CONTRACT CHANGE ORDER NO. 193
SHEET 2 OF 7

SAN FRANCISCO OAKLAND BAY BRIDGE
EAST SPAN SEISMIC SAFETY PROJECT
SELF-ANCHORED SUSPENSION BRIDGE
(SUPERSTRUCTURE & TOWER)

BIKEPATH DETAILS NO. 15

SAN FRANCISCO OAKLAND BAY BRIDGE
EAST SPAN SEISMIC SAFETY PROJECT
SELF-ANCHORED SUSPENSION BRIDGE
(SUPERSTRUCTURE & TOWER)
SKYWAY BIKEPATH EXPANSION JOINT REPLACEMENT NO. 1

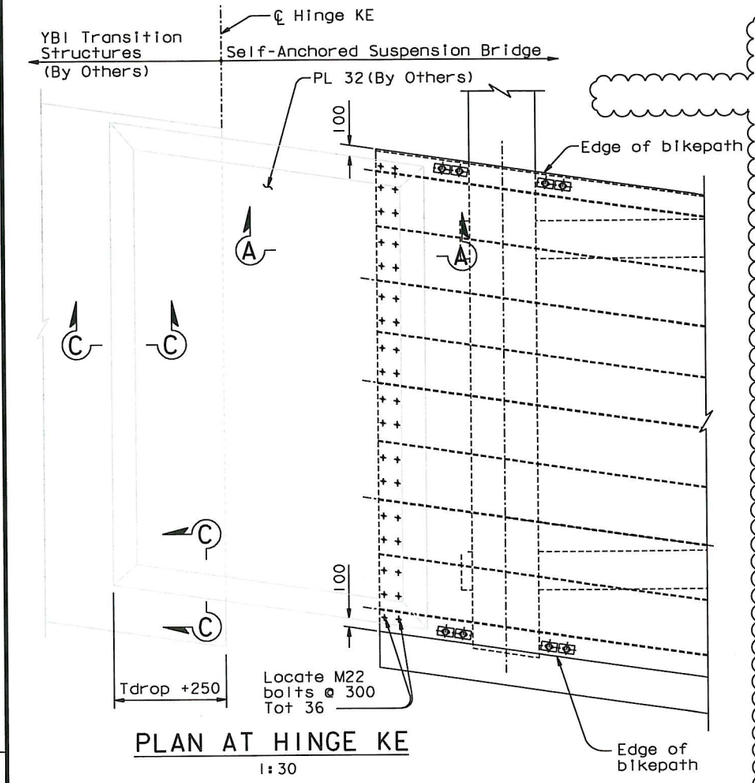
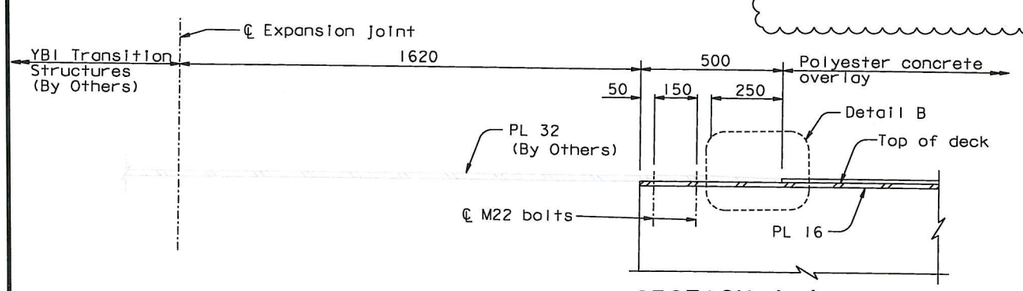
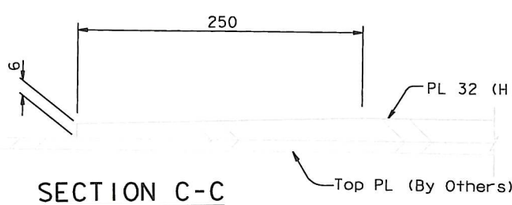
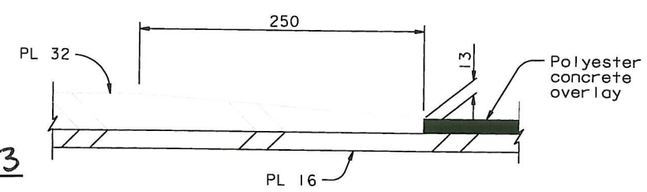
MARK	DATE	DESCRIPTIONS	BY	CH'D	CCO#
3	04/15/11	SKYWAY BIKEPATH EXPANSION JOINT	AS	TH	193
2	03/04/11	BIKEPATH DETAILS	CC	TH	99
1	08/20/10	BIKEPATH DETAILS	CC	TH	99

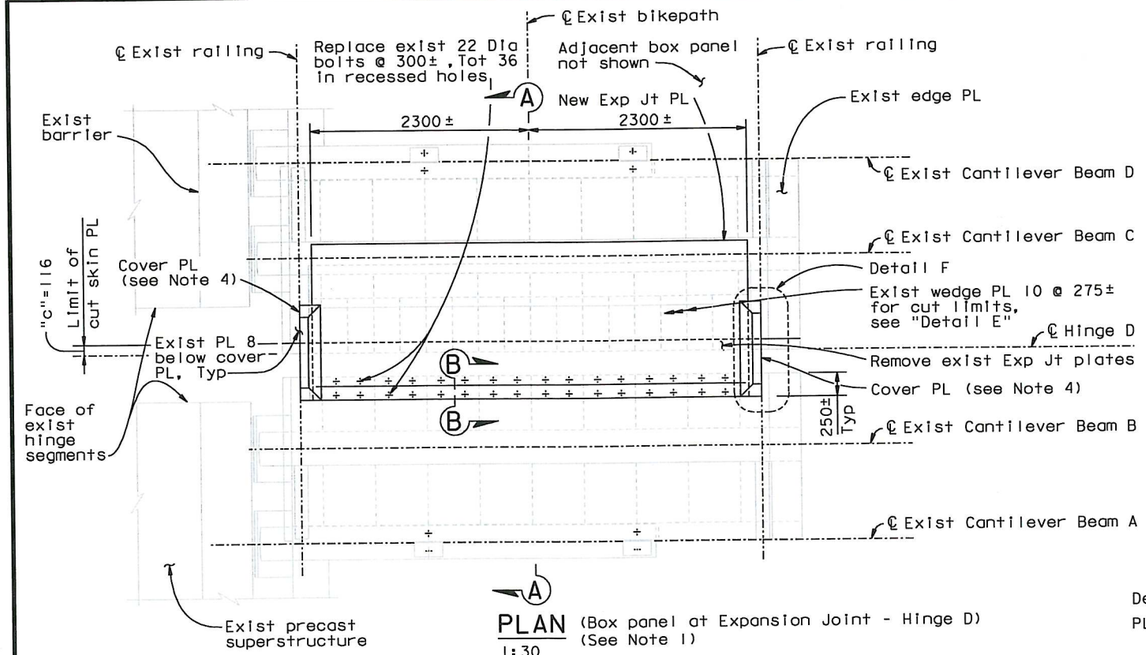
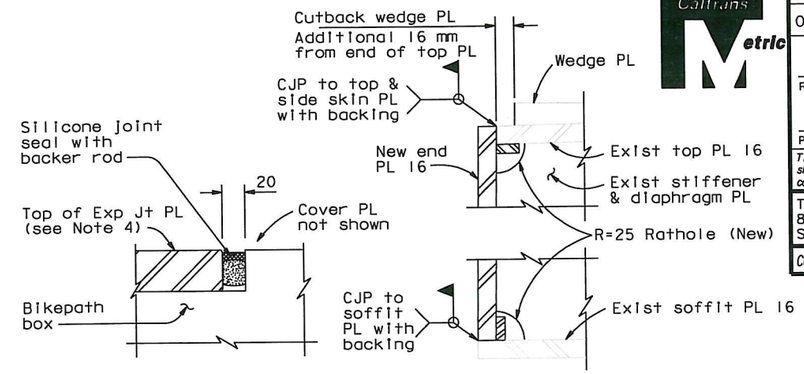
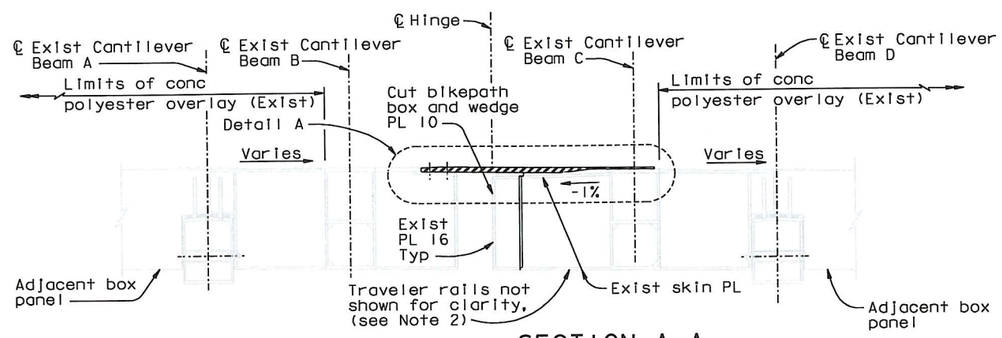
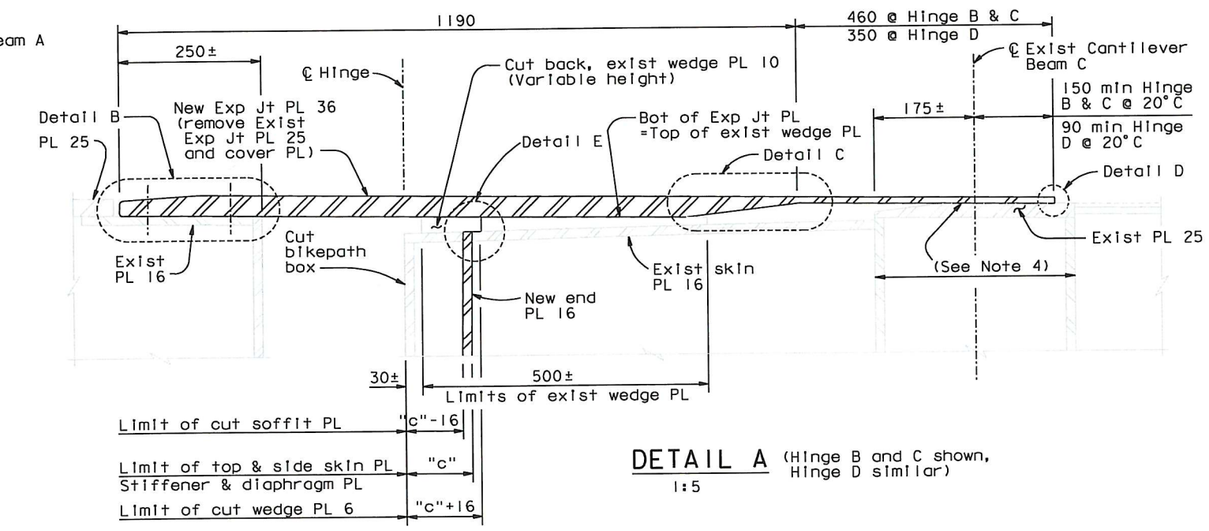
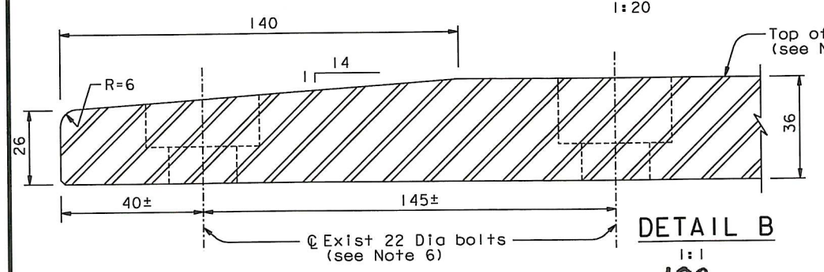
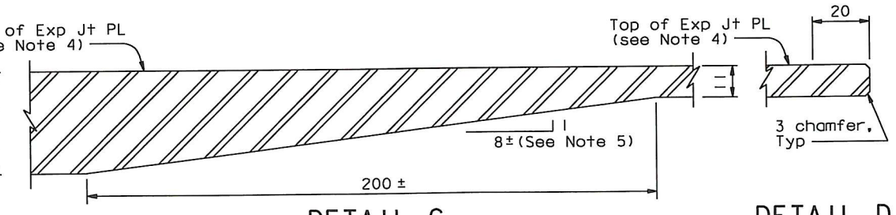
1. For Hinge B, C and Detail F, see "Skyway Bikepath Expansion Joint Replacement No. 2" sheet. For Hinge A, see "Skyway Bikepath Expansion Joint Replacement No. 3" sheet.
2. For traveler rail modifications, see "Skyway Bikepath Expansion Joint Replacement No. 4" sheet.
3. The Contractor shall verify all the dimensions in field before fabricating the expansion joint plate.
4. Top surface of exposed plates shall have non-skid coating.
5. Slope shall match the slope of exist top PL 25 of Cantilever Beam C.
6. Location and dimension of the countersunk holes shall be verified to match with exist holes in exist PL 16 and exist expansion joint plate. All the plates cut shall be ground square.

SKYWAY BIKEPATH EXPANSION JOINT REPLACEMENT NO. 2

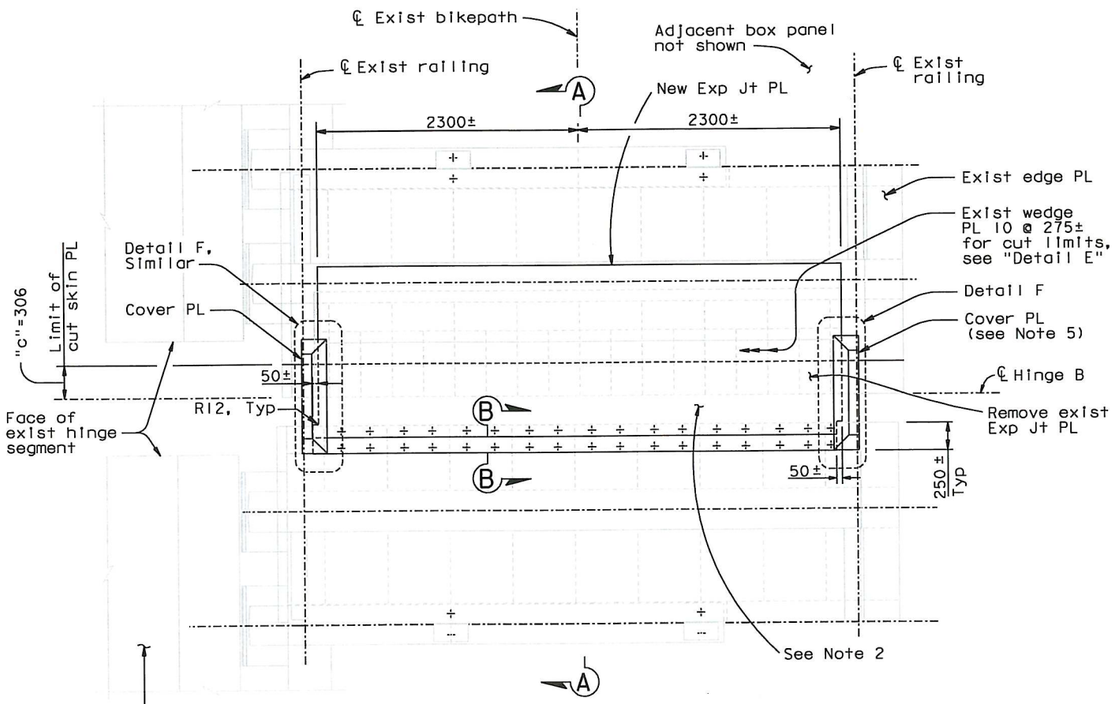
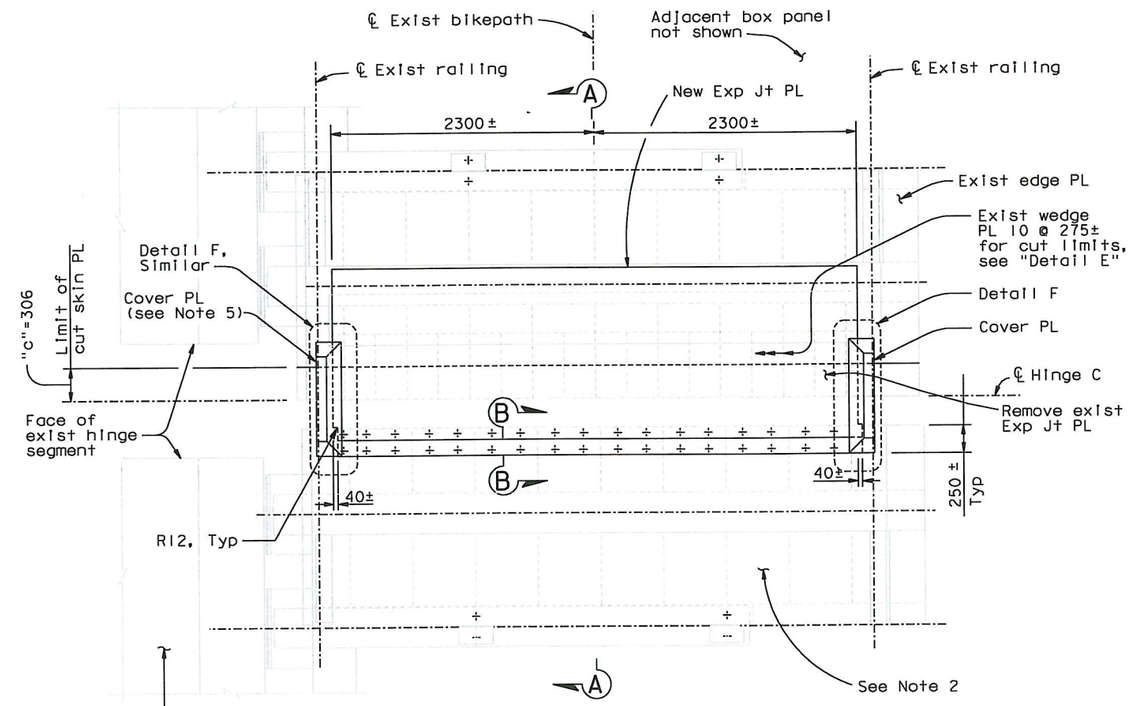
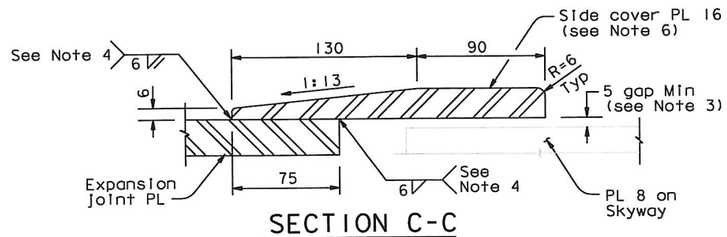
1. For Sections A-A and B-B, see "Skyway Bikepath Expansion Joint Replacement No. 1" sheet.
2. For details not shown, see Plan (Box panel at Expansion Joint - Hinge D) on "Skyway Bikepath Expansion Joint Replacement No. 1" sheet.
3. Cover PL may be shimmed to maintain Min gap shown.
4. Terminate the weld 12 mm short of the expansion joint PL taper at the bolted end. Caulk the space between the cover PL and the expansion joint PL at the tapered end of the expansion joint PL. At the Contractor's option, the weld between expansion joint PL and cover PL may be field weld.
5. Trim the cover PL as necessary to clear the expansion joint PL bolted connection.
6. Top surface of the exposed plates shall have non-skid coating.

SAN FRANCISCO OAKLAND BAY BRIDGE
EAST SPAN SEISMIC SAFETY PROJECT
SELF-ANCHORED SUSPENSION BRIDGE
(SUPERSTRUCTURE & TOWER)
SKYWAY BIKEPATH EXPANSION JOINT REPLACEMENT NO. 3

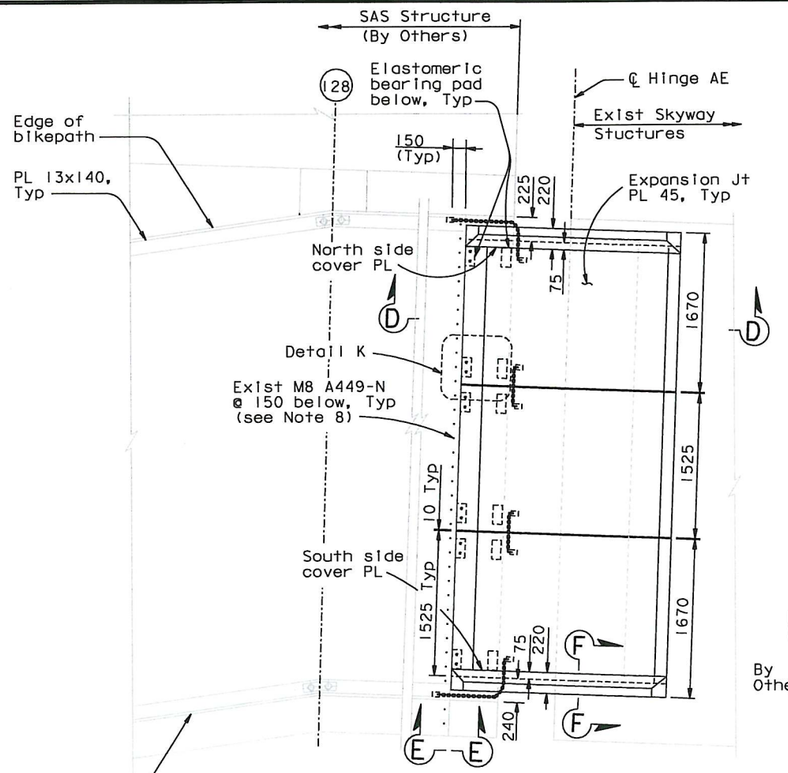
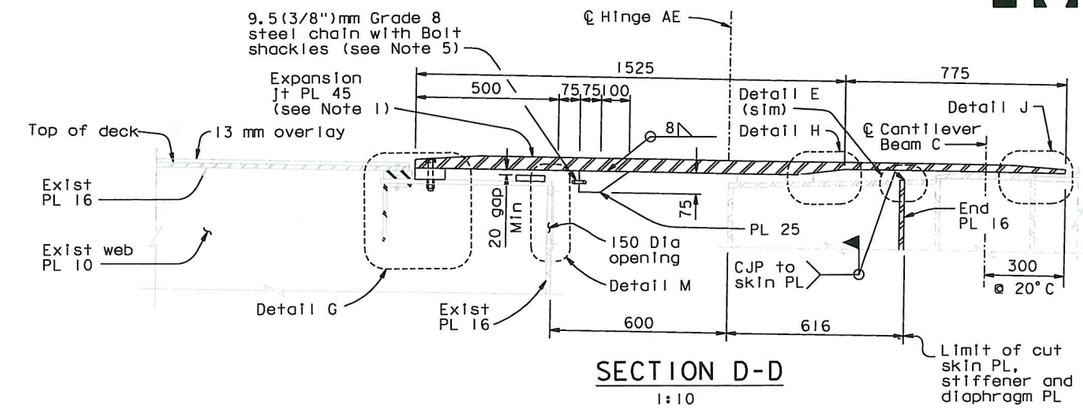
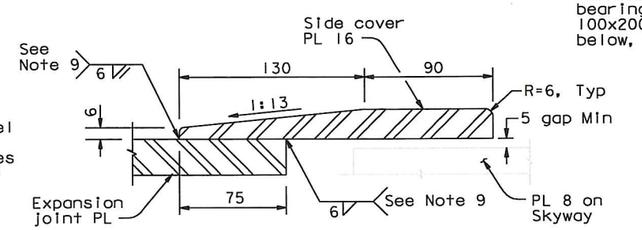
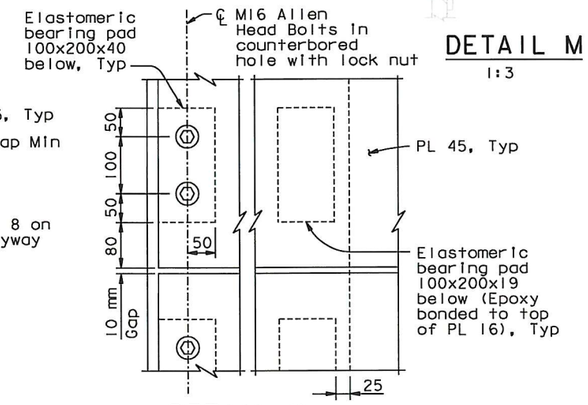
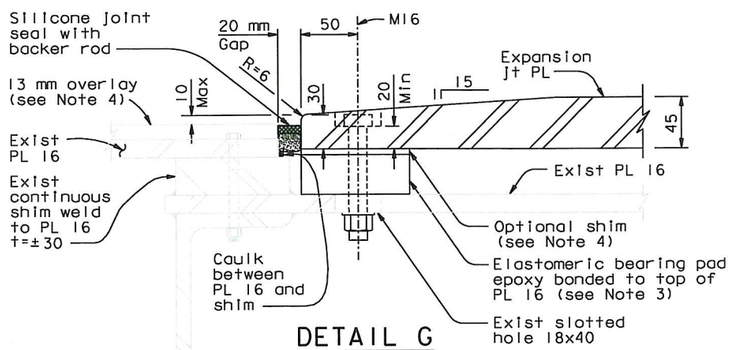
1. Top surface of exposed plates shall have non-skid coating.
2. For details not shown, see SAS-"Bikepath Details" sheets.
3. Pre-compress elastomeric pad by 2 mm by means of 1 turn of M16 bolt.

4. Thickness of shim and overlay may vary to provide tolerance to adjust for As-Built Skyway.
5. Chains and shackles should be hot-dipped galvanized and have a working capacity of 27kN. Chain drape shall not exceed 50 mm.

6. Slope shall match the slope of exist top PL of Cantilever Beam C.
7. The Contractor shall verify all the dimensions in field before fabricating the expansion joint plate. All the plates cut shall be ground square.

8. Bolts shall be installed with threads including in the shear plane.
9. Terminate the weld 12 mm short of the expansion joint PL taper at the bolted end. Caulk the space between the cover PL and the expansion joint PL at the tapered end of the expansion joint PL.

10. For detail E, see "Skyway Bikepath Expansion Joint Replacement No.1" sheet.

SKYWAY BIKEPATH EXPANSION JOINT REPLACEMENT NO. 4

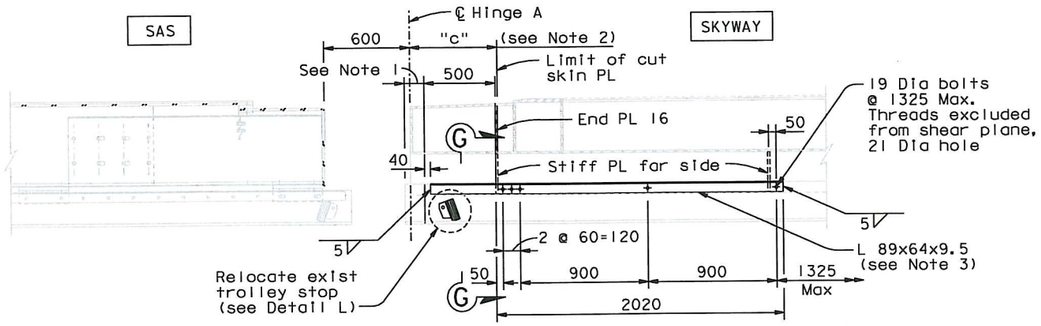
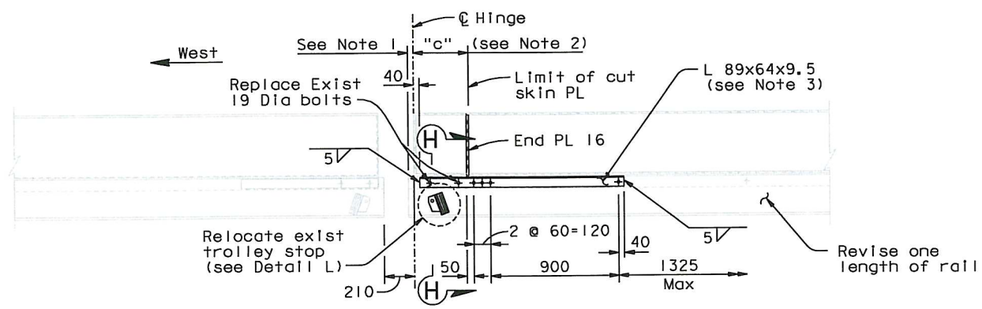
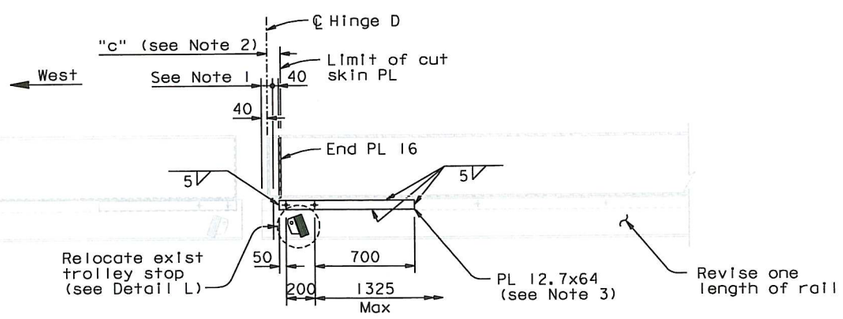
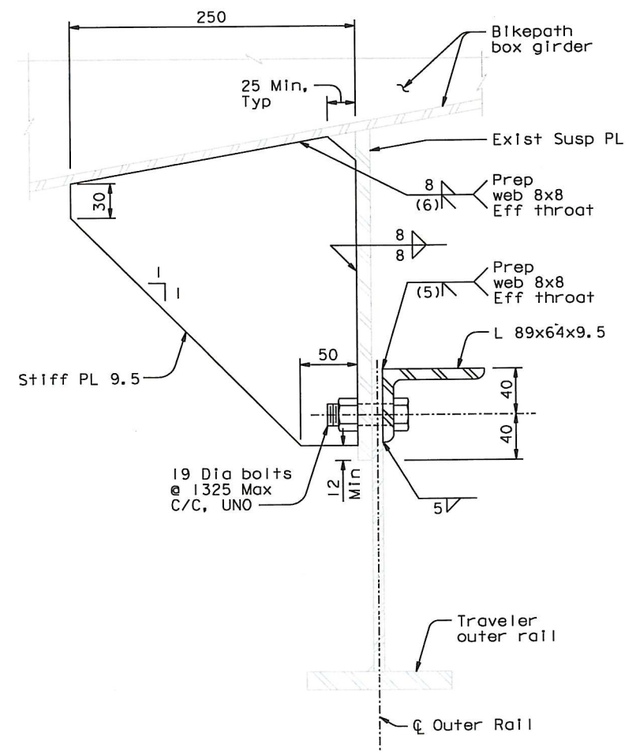
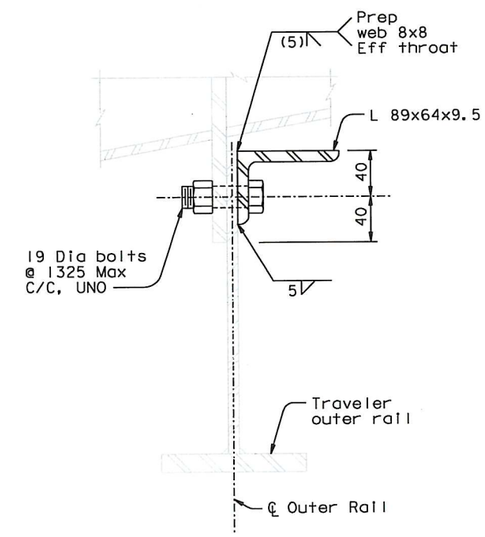
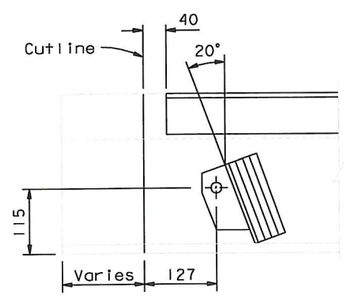
1. Cut the traveler rail as shown. All the plates cut be ground square.
2. For dimension "c", see "Skyway Bikepath Expansion Joint Replacement No. 1 thru No. 3" sheets.
3. At the Contractor's option, the last segment of rail may be disassembled and lowered to facilitate welding between L89x64 and exist suspension PL.
